Service Bulletin

Bulletin No.: PIC5667

Subject: Service Power Steering Message DTC C0800

Models: 2011 - 2012 Chevrolet Volt

2814516

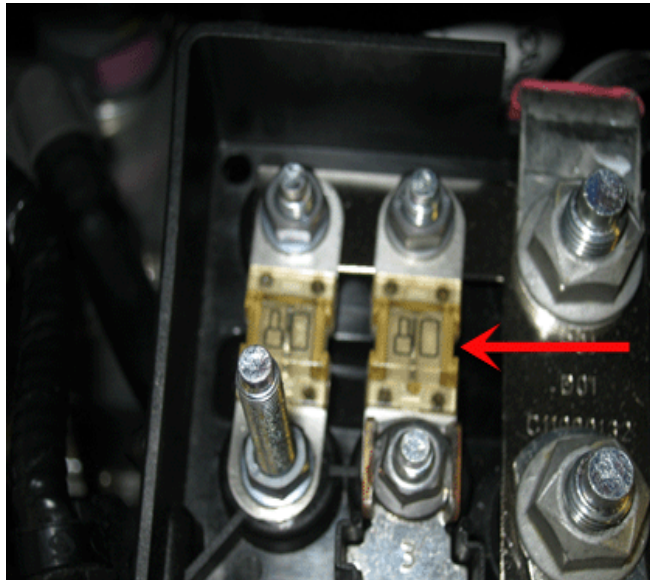
1. Check the F2UB (80 amp) fuse connection in the X50 auxiliary underhood fusebox. Check for a loose connection by checking the torque on the nut. Also check for any signs of arcing. If there is signs of arcing, replace the fuse and torque to the proper spec's.

2814517

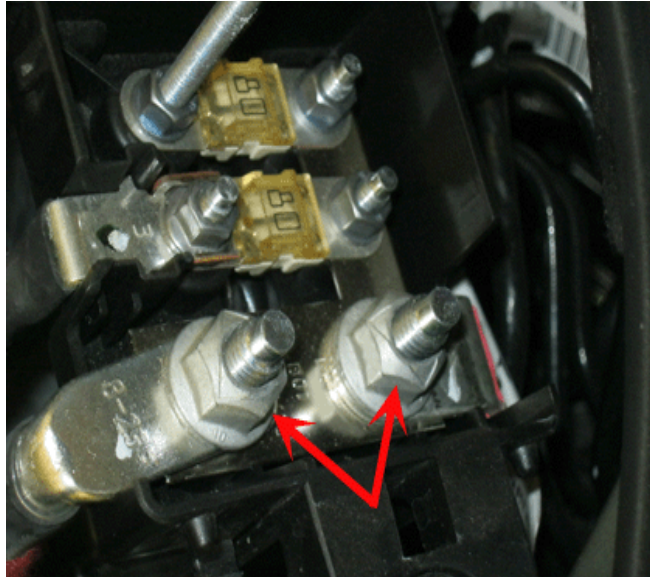
2. Check the torque on the main power feeds cable at the X50 auxiliary underhood fusebox. If loose, torque to factory spec's and retest system.
